VIRGINIA ELECTRIC AND POWER COMPANY
NORTH ANNA POWER STATION UNIT 1
INSERVICE INSPECTION PROGRAM RELIEF REQUEST

NORTH ANNA UNIT 1
RELIEF REQUEST NDE-20 REVISION 2

NORTH ANNA UNIT 1
RELIEF REQUEST NDE-26

SKETCH 1A

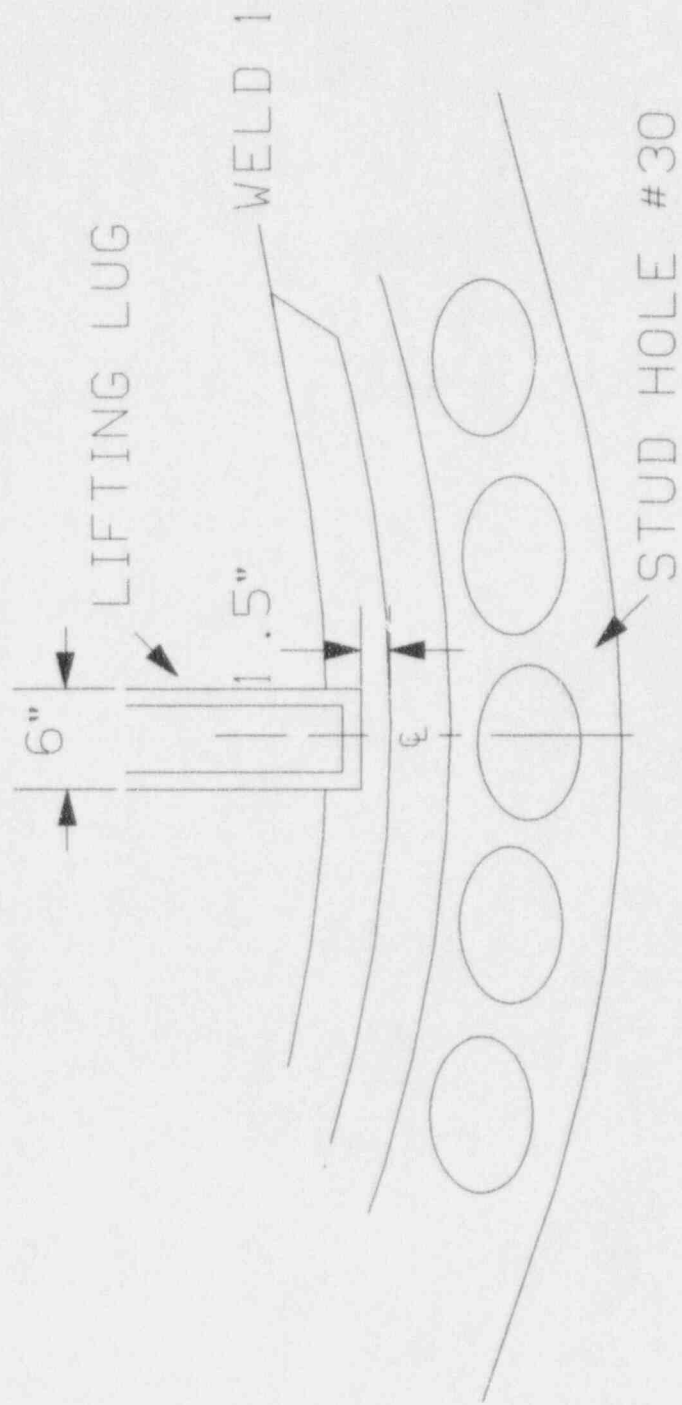
<u>Mark/Weld #</u>	<u>Beam Angle</u>	<u>Exam Area</u>	<u>Scan Direction</u>	<u>% Exam</u>	<u>Reason For Partial</u>	<u>Sketch#</u>
1 (120° - 240°)	0	Weld & Base	-	72	Joint Configuration And Lifting Lug Interference	1A & 1B
	45	Weld	2	13		
	45	Weld	5	97		
	45	Weld	7	99		
	45	Weld	8	99		
	60	Weld	2	7		
	60	Weld	5	98		
	60	Weld	7	99		
	60	Weld	8	99		
	45 & 60	Base	2	36		
	45 & 60	Base	5	91		
	45 & 60	Base	7	68		
	45 & 60	Base	8	68

SKETCH 3

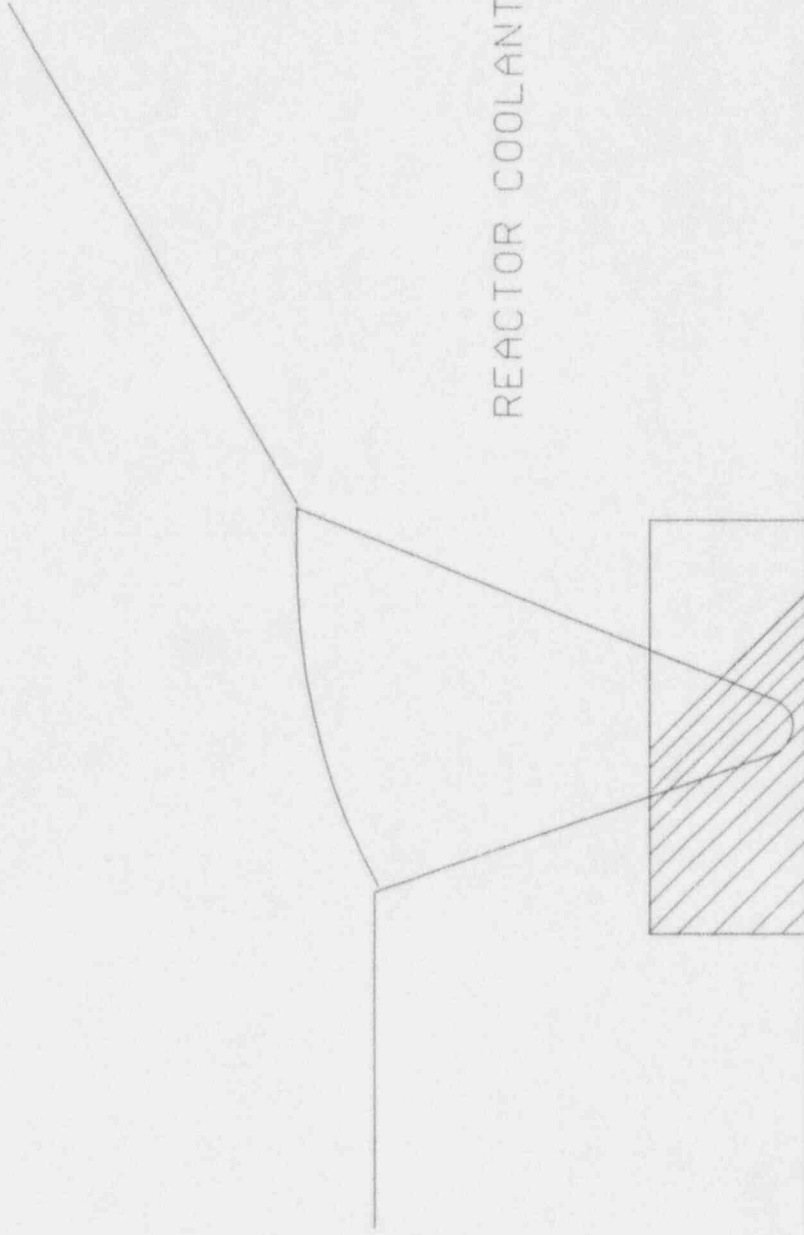
<u>Mark/Weld#</u>	<u>Category</u>	<u>Item #</u>	<u>UT Scan Coverage %</u>				<u>Surface Coverage %</u>	<u>Reason For Partial</u>	<u>Sketch#</u>
			<u>2</u>	<u>5</u>	<u>7</u>	<u>8</u>			
37	B-J	B9.11	75	0	90	90	100	Nozzle and Weld Geometry, Material Attenuation Prevent	3
SW-39	B-J	B9.31	90	0	27	27	100	Branch Connect Configuration	4
SW-19	B-J	B9.31	90	0	27	27	100	Branch Connect Configuration	4
SW-41	B-J	B9.31	90	0	27	27	100	Branch Connect Configuration	4
SW-42	B-J	B9.31	90	0	27	27	100	Branch Connect Configuration	4

11715-WMKS-SI-TK-2
WELD 1

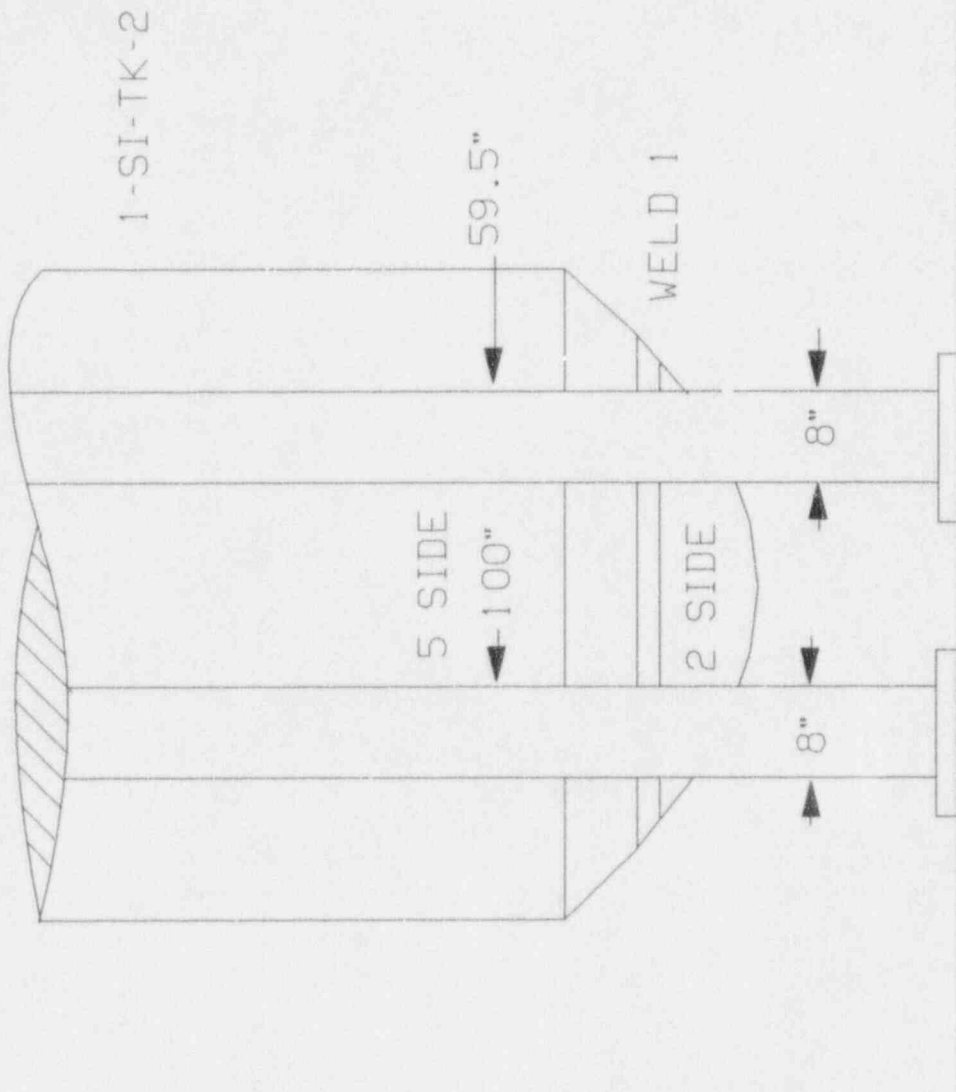
<u>Mark/Weld #</u>	<u>Beam Angle</u>	<u>Exam Area</u>	<u>Scan Direction</u>	<u>% Exam</u>	<u>Reason For Partial</u>	<u>Sketch #</u>
1 (58" - 116")	0	Weld & Base	-	91	Support Legs 3 and 4	5
	45	Weld	2	95		
	45	Weld	5	82		
	45	Weld	7	100		
	45	Weld	8	100		
	60	Weld	2	99		
	60	Weld	5	78		
	60	Weld	7	100		
	60	Weld	8	100		
	45 & 60	Base	2	98		
	45 & 60	Base	5	80		
	45 & 60	Base	7 (2 side)	100		
	45 & 60	Base	8 (2 side)	100		
	45 & 60	Base	7 (5 side)	87		
	45 & 60	Base	8 (5 side)	87

SKETCH 1

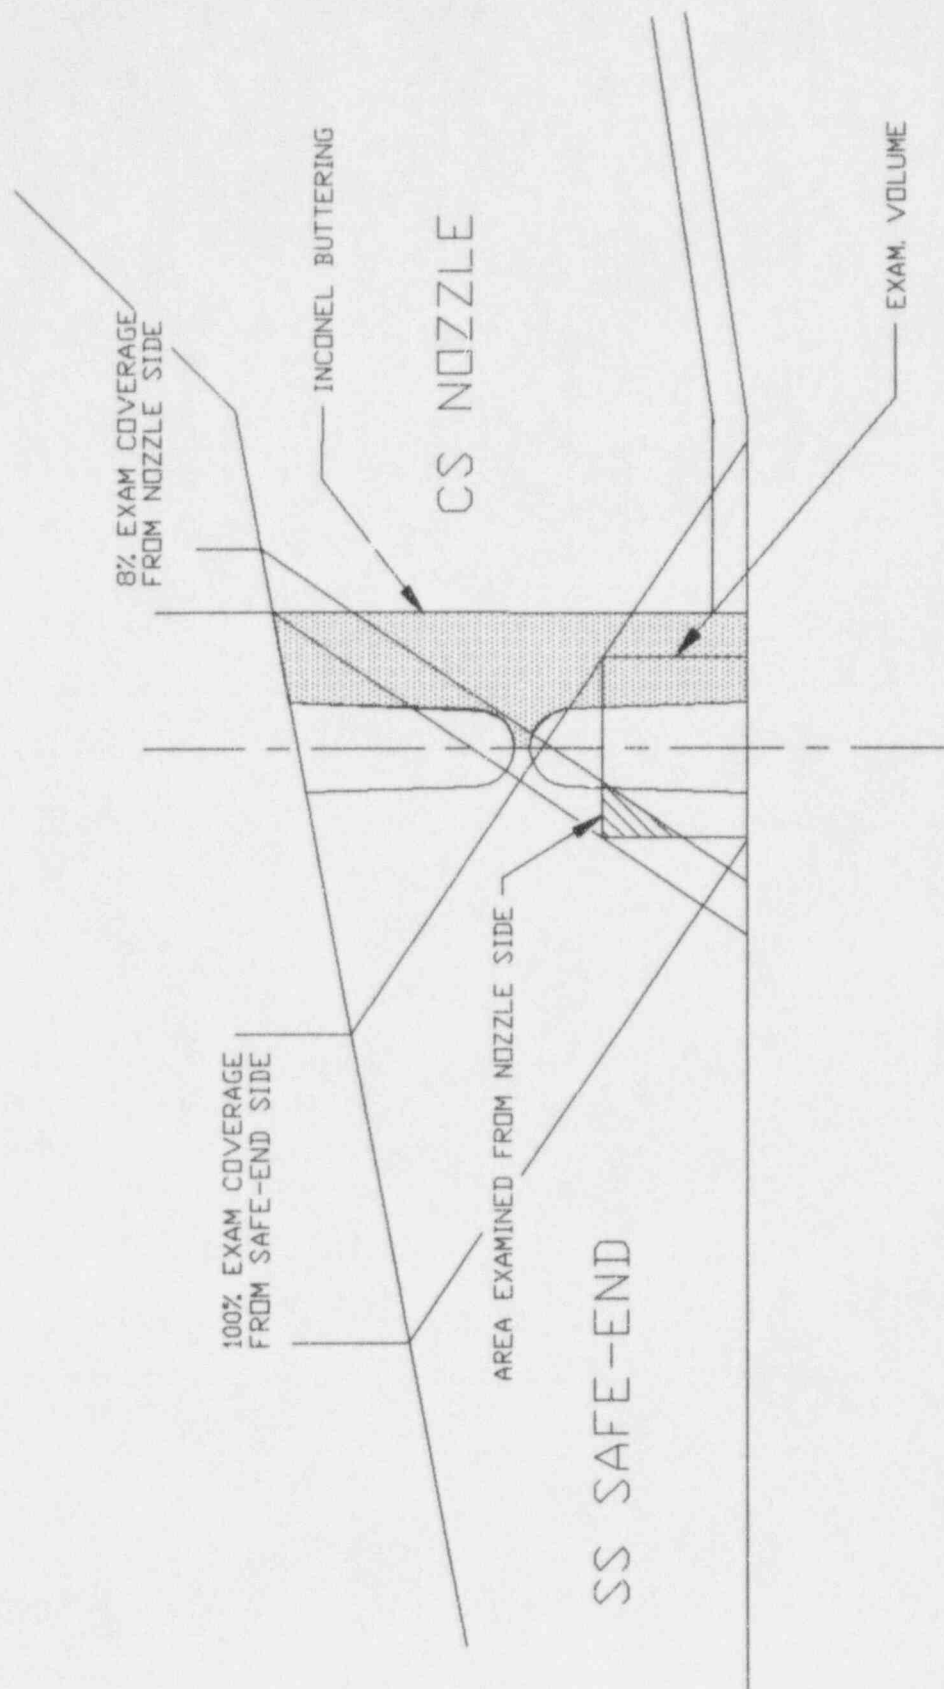
Mark/Weld#	Category	Item #	UT Scan Coverage %				Surface Coverage %	Reason For Partial	Sketch#
			2	5	7	8			
N-SE-29 IN (A)	B-F	B5.70	8	100	100	100	100	Nozzle Geometry, Material Attenuation Prevent Extended V-Path	1
N-SE-31 IN (A)	B-F	B5.70	100	8	100	100	100	Nozzle Geometry, Material Attenuation Prevent Extended V-Path	1
N-SE-29 IN (B)	B-F	B5.70	8	100	100	100	100	Nozzle Geometry, Material Attenuation Prevent Extended V-Path	1
N-SE-31 IN (B)	B-F	B5.70	100	8	100	100	100	Nozzle Geometry, Material Attenuation Prevent Extended V-Path	1
N-SE-29 IN (C)	B-F	B5.70	8	100	100	100	100	Nozzle Geometry, Material Attenuation Prevent Extended V-Path	1
N-SE-31 IN (C)	B-F	B5.70	100	8	100	100	100	Nozzle Geometry, Material Attenuation Prevent Extended V-Path	1
4A	B-J	B9.11	100	70	75	75	100	Nozzle & Weld Crown Geometry, Material Attenuation Prevent Extended V-Path	2
5A	B-J	B9.11	91	94	80	80	100	Nozzle & Weld Crown Geometry, Material Attenuation Prevent Extended V-Path	2

SKETCH 2

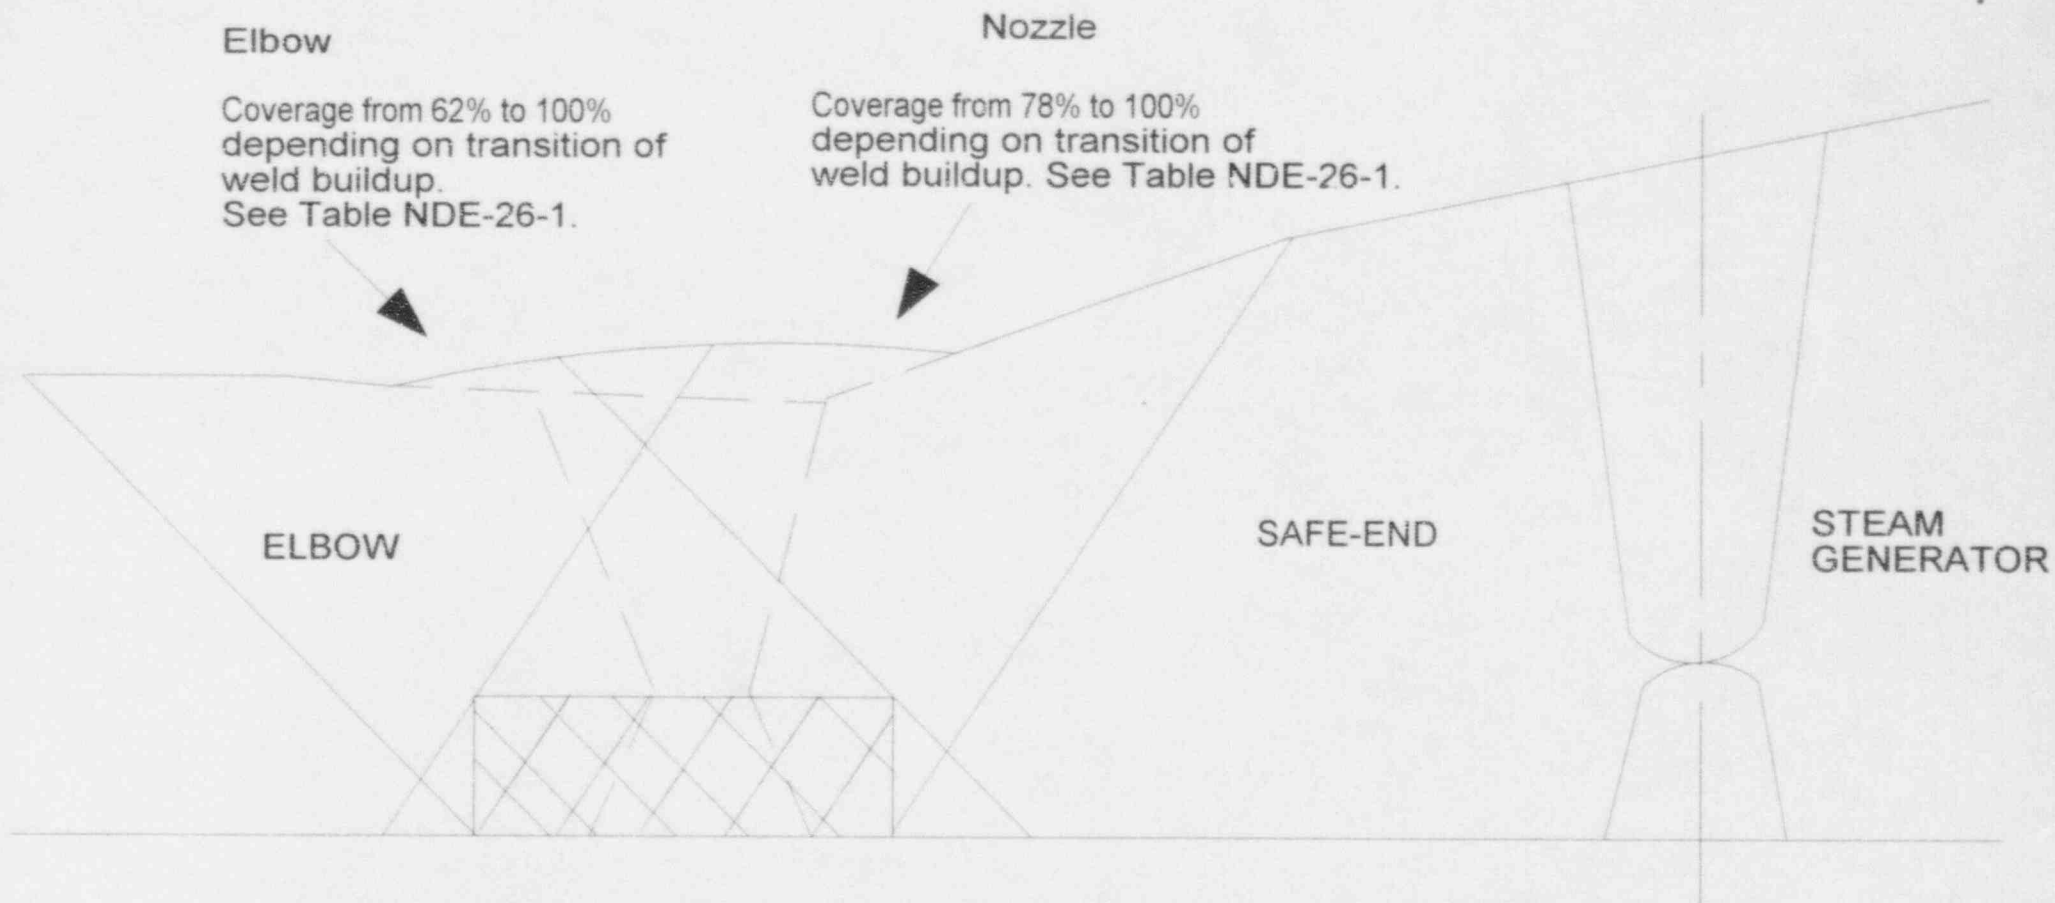
16A	B-J	B9.11	100	62	90	90	100	Nozzle & Weld Crown Geometry, Material Attenuation Prevent Extended V-Path	2
17A	B-J	B9.11	62	100	90	90	100	Nozzle & Weld Crown Geometry, Material Attenuation Prevent Extended V-Path	2
28A	B-J	B9.11	78	100	90	90	100	Nozzle & Weld Crown Geometry, Material Attenuation Prevent Extended V-Path	2
29A	B-J	B9.11	83	100	90	90	100	Nozzle & Weld Crown Geometry, Material Attenuation Prevent Extended V-Path	2
